STAFF REPORT

CITY OF COLUMBUS PLAN COMMISSION (March 13, 2024 Meeting)

Docket No. / Project Title: CDP-2024-001 (Lillian Schmitt Elementary)
Staff: Andres M. Nieto

Applicant: Bartholomew Consolidated School Corporation
Property Size: +/- 9.05 acres
Current Zoning: P (Public/Semi-Public Facilities)
Location: 2675 California Street, in the City of Columbus.

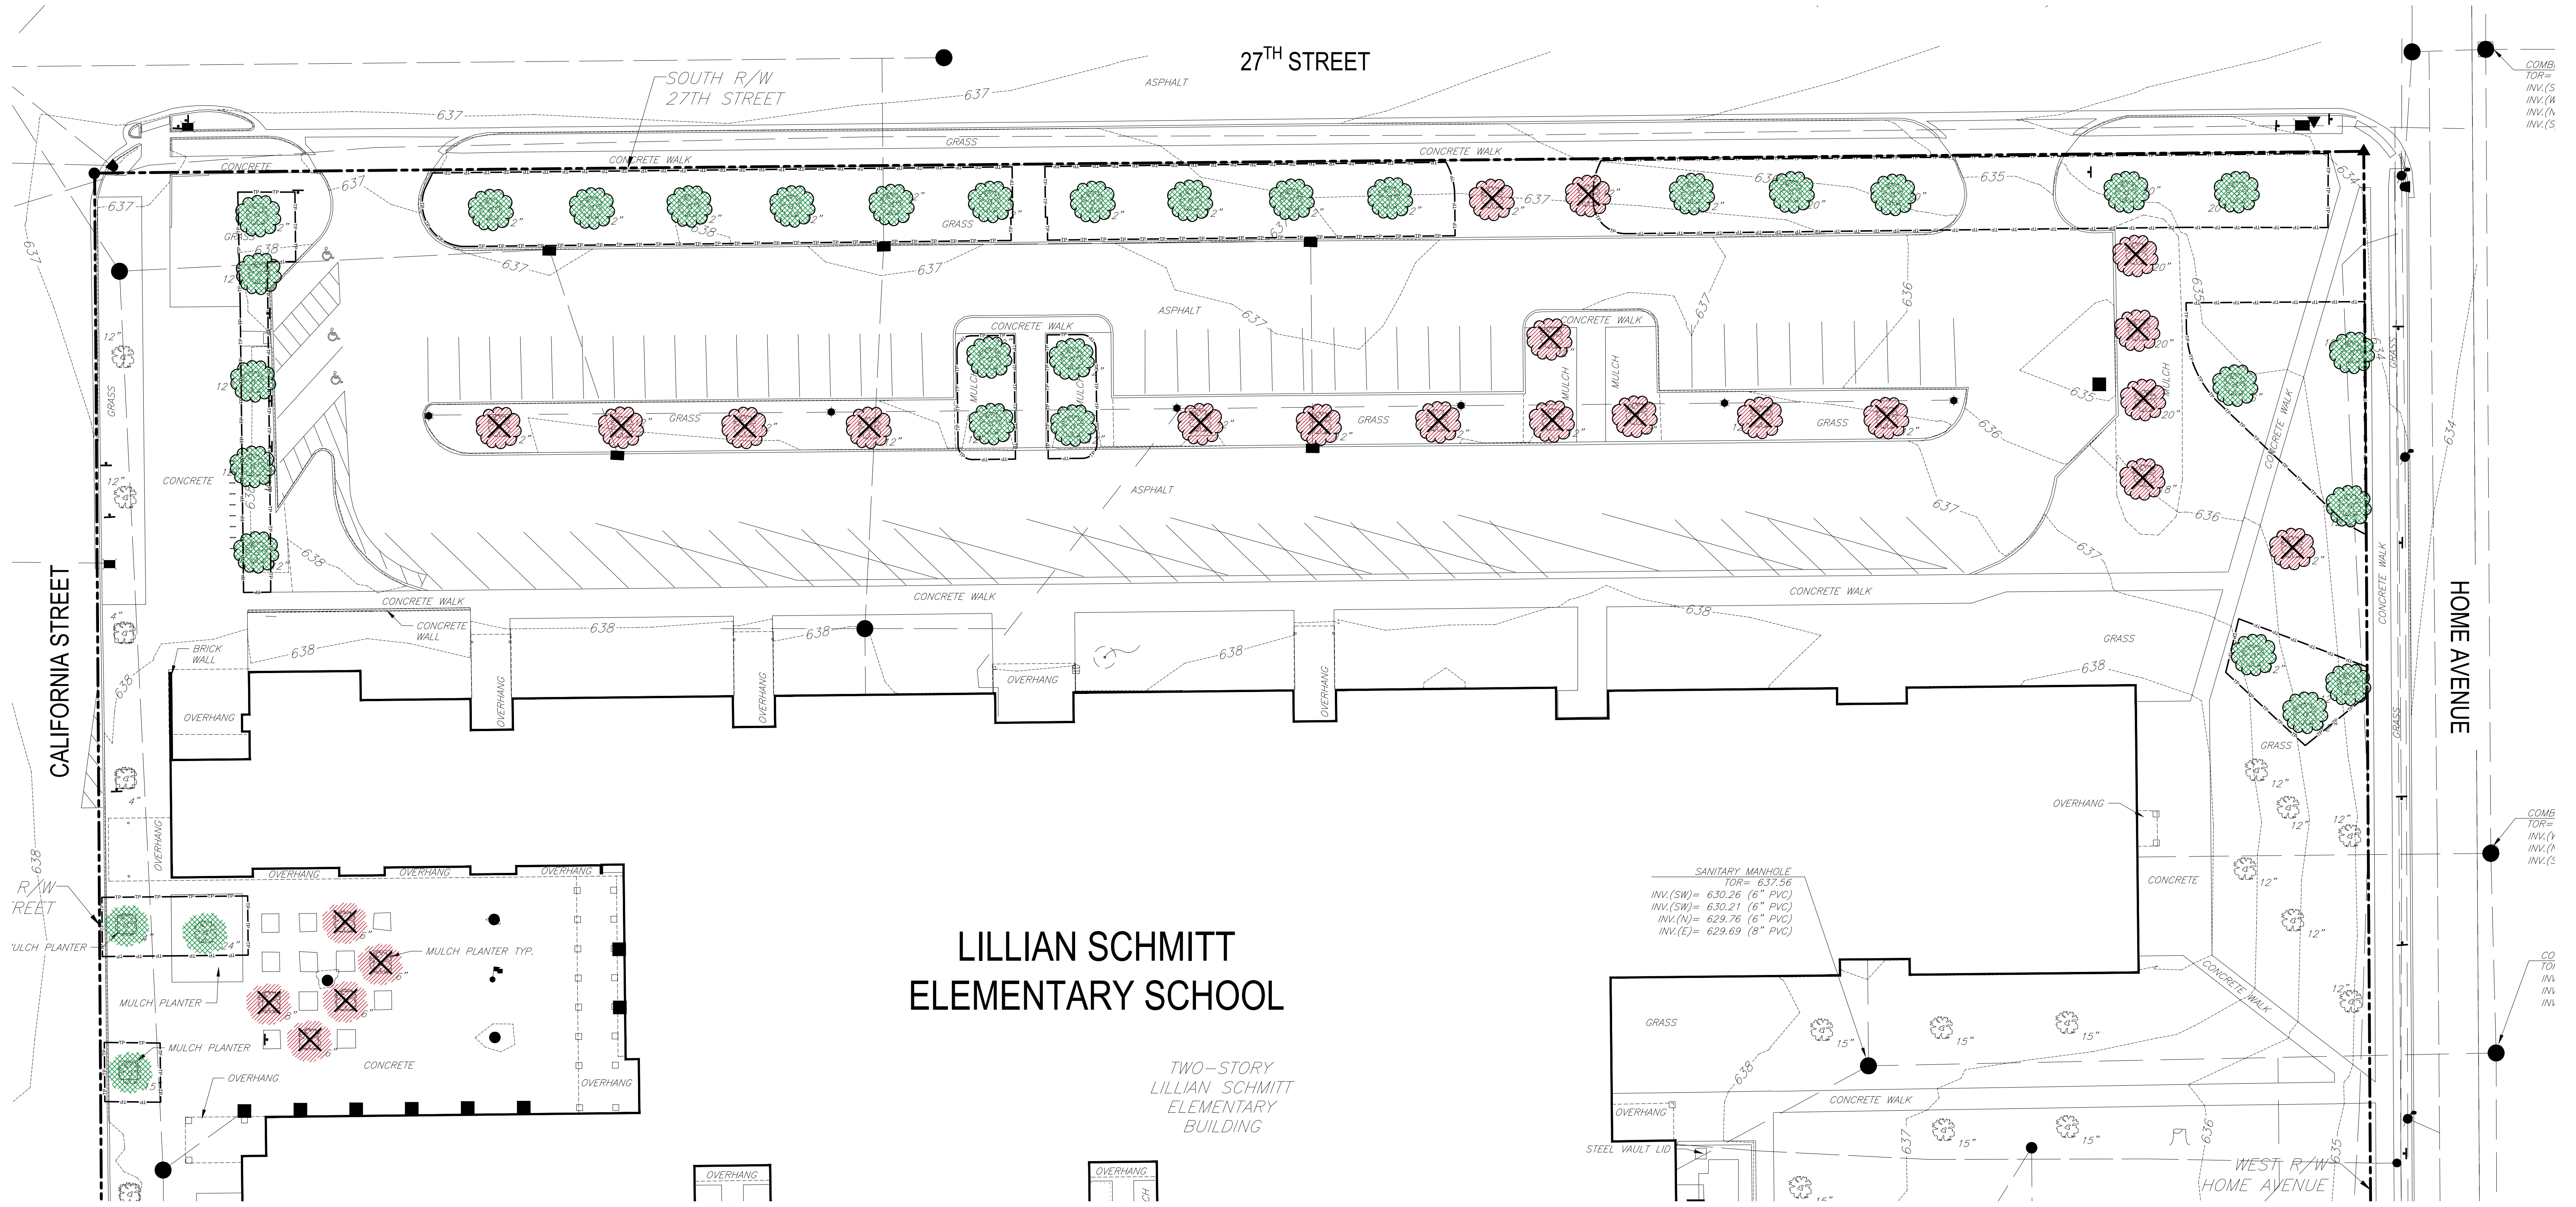
5. The proposed new access to 27th Street will be aligned with a residential driveway across the street, but will be separated by only 95 feet from the next residential driveway to the east (measured at the driveway centerlines). The minimum driveway separation required by the zoning ordinance for those along 27th Street is 200 feet. The proposed driveway will be 260 feet from the Home Avenue intersection (again measured from the centerlines). This proposed drive will replace an existing driveway on 27th Street that is 125 feet from the Home Avenue intersection and 43 feet from the nearest residential driveway.

6. A second, existing driveway onto 27th Street, located on the west side of the property, is proposed to remain in its current location.
7. The proposed new access to Home Avenue would be an additional driveway on the property. It is located 142 feet from the 27th Street intersection and 54 feet from a driveway for the Columbus North High School parking lot across Home Avenue. The minimum driveway separation required by the zoning ordinance for those along Home Avenue is also 200 feet. This new driveway is proposed to be exit only.

10. This parking lot reconfiguration will require the removal/replacement of several trees currently located on the street frontage and within the parking lot landscaping areas. The submitted site plan shows the removal of 2 street trees along 27th Street where the new drive access will be constructed. The submitted plans do not show the replacement of these tree(s) where the current access point will be removed and replaced to grass.

11. The existing landscaping on the 27th Street frontage is legal non-conforming since it was installed before the current Zoning Ordinance requirements. Removing these 2 trees without replacing them elsewhere would increase this non-conformity, creating a zoning violation. The current Zoning Ordinance would require this parking lot frontage (+/- 550 linear feet) to incorporate a minimum of 11 large trees or 14 medium trees, plus 83 shrubs.

12. Other landscaping changes are planned for the California Street and Home Avenue frontages. The California Street parking lot frontage landscaping will not increase in non-conformity. The Home Avenue parking lot frontage landscaping will increase in non-conformity by removing 5 existing trees and replacing them with only two trees and 5 shrubs, creating a zoning violation. The current Zoning Ordinance would require the parking lot frontage (+/- 100 linear feet) to incorporate a minimum of 2 large trees or 3 medium trees, plus 15 shrubs.

3. All driveway separation dimensions on all drawing sheets shall be shown as between driveway and street intersection centerlines (Zoning Ordinance Section 7.3(Part 1)(C)(3)).

5. Two additional trees, meeting the requirements of the Zoning Ordinance, shall be provided along the 27th Street parking lot street frontage, maintaining the legal-nonconforming total of 17 trees in that area (Zoning Ordinance Sections 8.1(C)(1) and 11.4(B)(1)).

6. Either replace the 5 trees to be removed in the Home Avenue Parking Lot Street Frontage landscaping area, or provide an additional 10 shrubs in this landscape area, meeting the specifications of the Zoning Ordinance (Section 8.1(C)(1) and 11.4(B)(1)).

LANDSCAPE ORDINANCE REQUIREMENTS

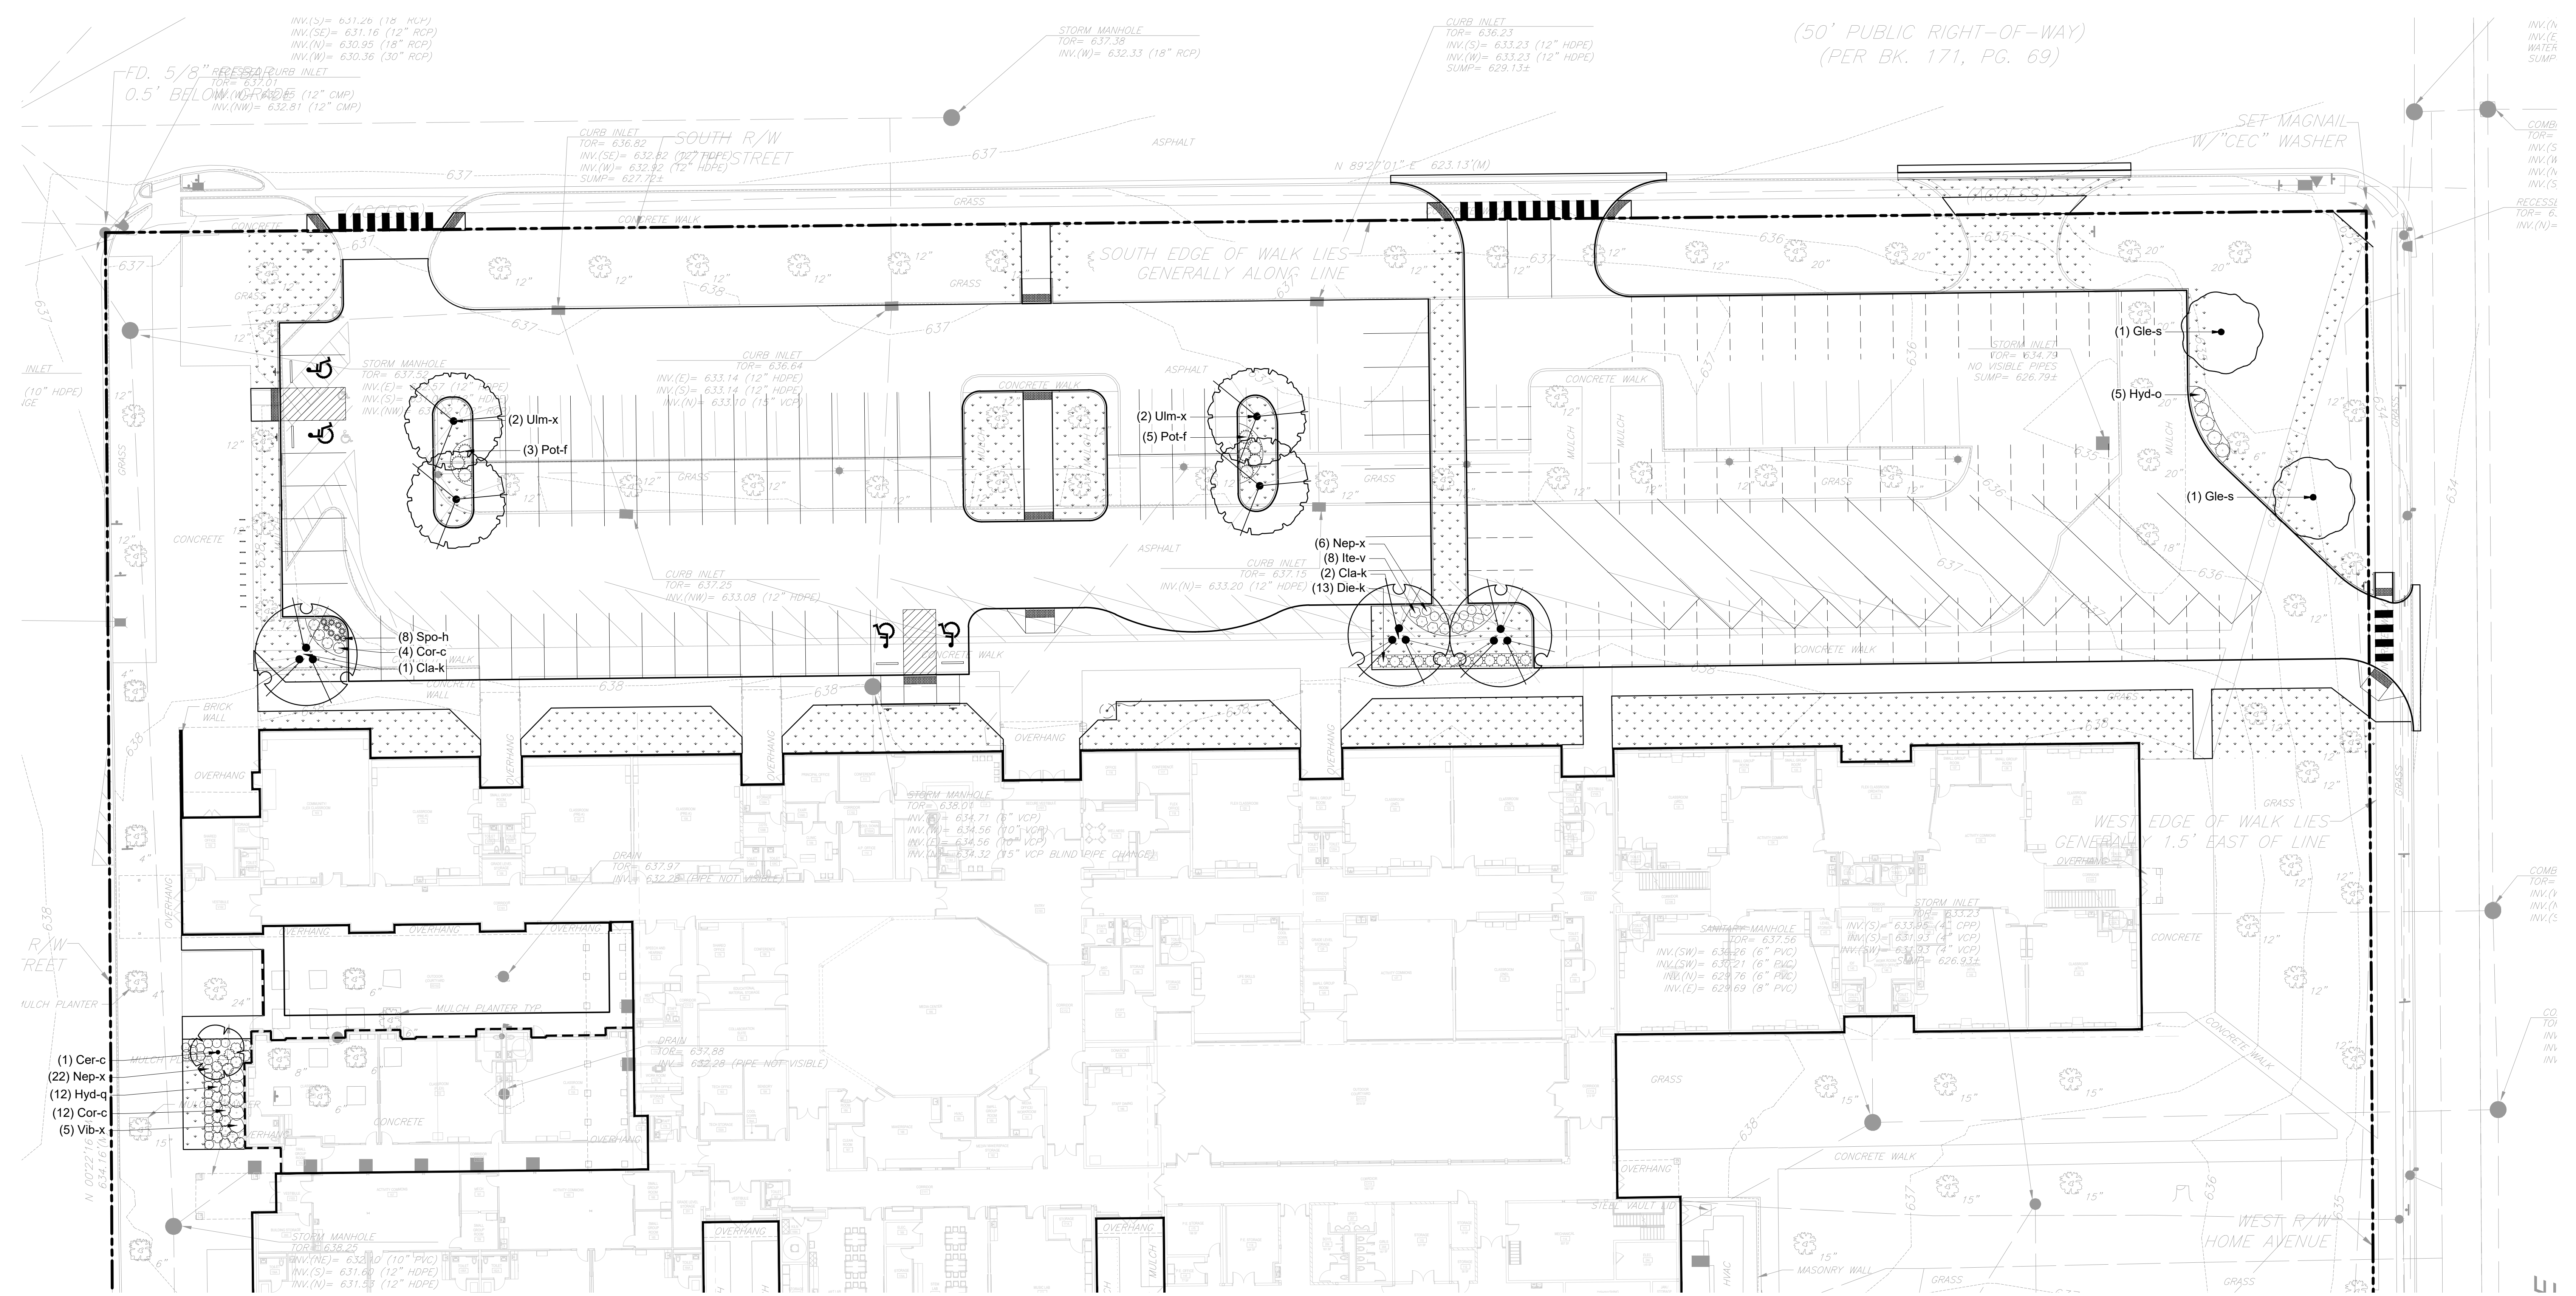
4. An additional 2 trees and 5 shrubs, meeting the specifications of the Zoning Ordinance, (for a total of 9 trees and 54 shrubs) shall be included in the parking lot interior landscaped area (Zoning Ordinance Section 8.1(C)(2)).

13. The submitted plans include new, additional landscaping that would not meet the requirements specified in the Zoning Ordinance for the parking lot interior. The zoning ordinance requires a minimum of 2,702 square feet of parking lot interior landscaped area for the new parking lot, with a total of 9 trees and 54 shrubs also required. The applicants are currently proposing 3,285 square feet of landscaped area with 7 trees and 49 shrubs.
